Interactive comment on “Implementation of Polarization Diversity Pulse Pair Technique using airborne W-band radar” by Mengistu Wolde et al.

Received and published: 19 November 2018

Fig. 1. 12 Z soundings the horizontal wind speed and direction obtained from two nearby radiosonde stations

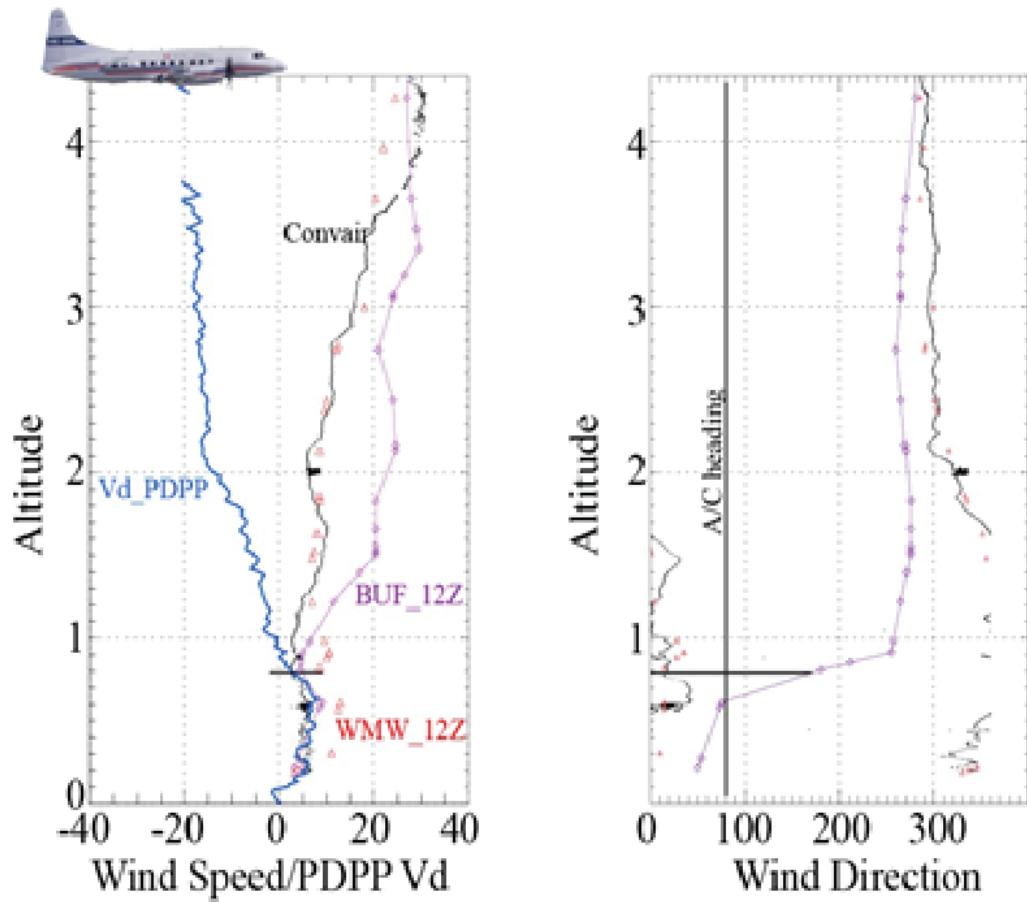
1. *EarthCARE CPR is designed for cloud vertical velocity measurements while WIVERN is target for horizontal wind retrieval. Have the author done or planned to do any horizontal wind retrieval based on airborne data?*

The objective of the project was to demonstrate the PDPP technique from a moving platform so our flight profiles were not optimized to do comparison of PDPP derived horizontal winds with vertical profile of horizontal winds. Even for the WIVERN satellite the scope is to measure horizontal winds along the line of sight and the information

However, we did a limited qualitative comparison of the PDPP Doppler velocity with a horizontal wind component obtained from radiosonde at proximity of the flight and the in-situ wind data measured by the aircraft wind system. In Fig. 1 (see attached), we plotted the 12 Z soundings (approximately 2 hours before the PDPP data collection) of the horizontal wind speed and direction obtained from two nearby radiosonde stations. In spite of the time and location differences of the soundings, both the radiosonde and aircraft sounding show a similar horizontal wind profile as the region was influenced by large scale synoptic system. The winds between 2 and 5 km were WNW with speed decreasing with altitude from 25 m/s at the aircraft altitude to nearly 5 m/s at 2 km altitude. Below 2 km, the wind veers with decreasing altitude and becoming light (< 10 m/s) north easterly. In this lower layer, the contributions of the terminal velocity from rain drops cannot be neglected so the Doppler velocity is a combination wind and particle fall velocity. These wind profiles are consistent with the PDPP observations showing a gradual decrease in magnitude from -20 m/s near flight level due to strong westerly winds (aircraft flying towards east) then reverse direction to weak vD of 0-10 m/s in a layer where winds were north easterly (opposite to aircraft heading).

Figures 2, 3 and 4: PDPP Z_{hh} , Z_{hv} and retrieval Doppler for the March 29th, 2016 case.

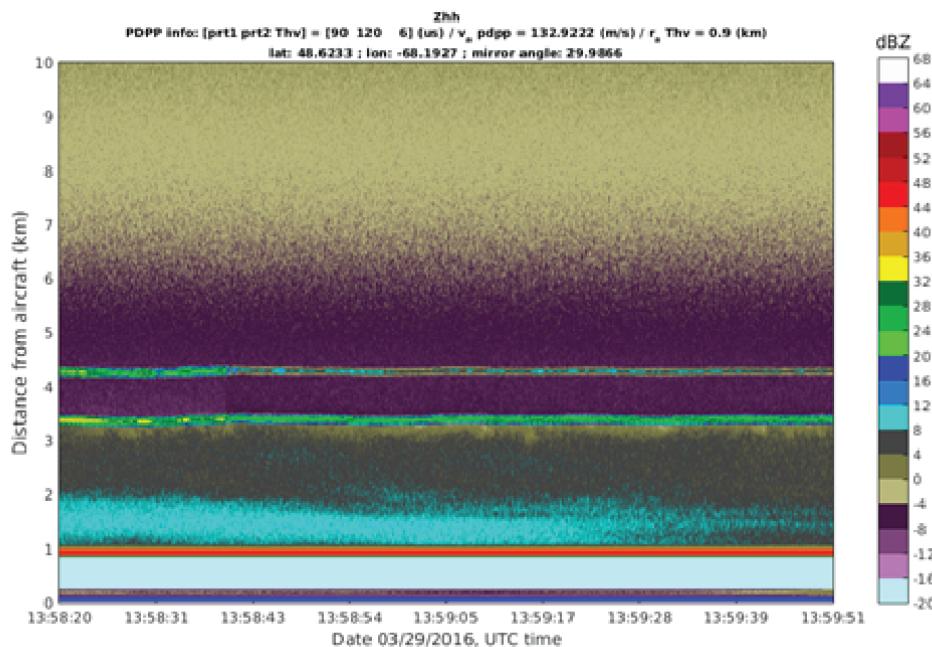
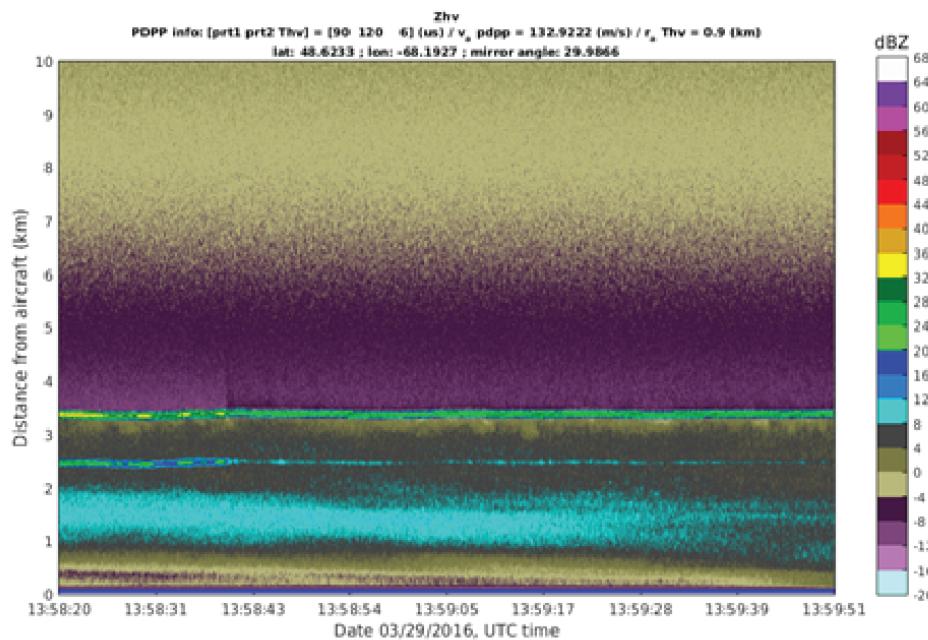
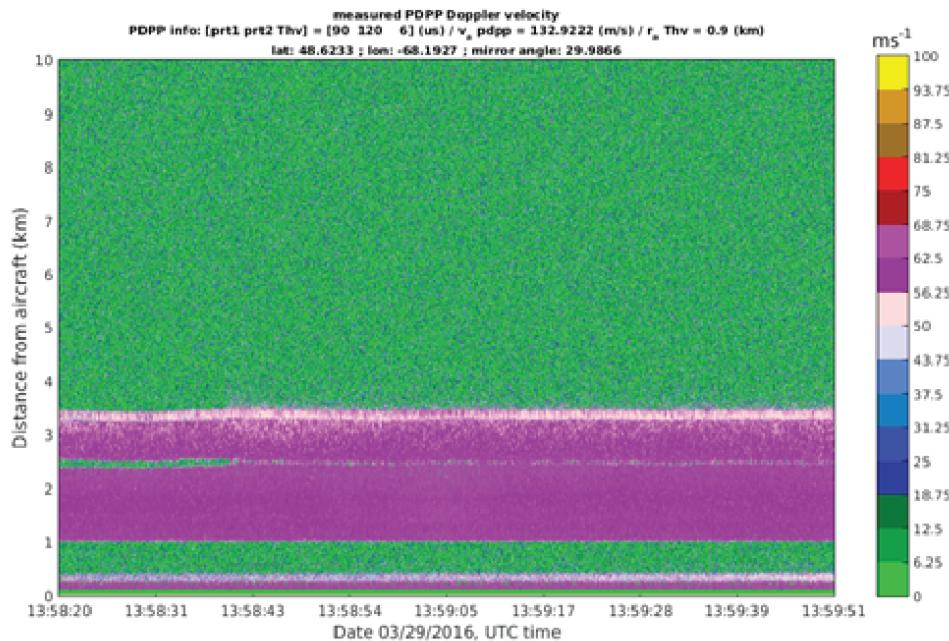
3. *What is the cross-pol isolation of NAWX channels? The SNR in the data case shown in Figure 9 seems high so the surface contamination from cross-pol seems not very significant. Is there any data case with weaker cloud/precipitation layer(s)?*

The cross-polarization isolation of the W-band channels mainly limited by the cross-pol of the antennas which is 30 dB for E-plane and 36 dB for H-plane. We have collected a few data sets where the SNR of cloud layers was low and cross-pol signals were much more significant (see Figs. 2-4). In those cases, Doppler velocities showed large errors or were not available in regions contaminated by cross-pol signals.
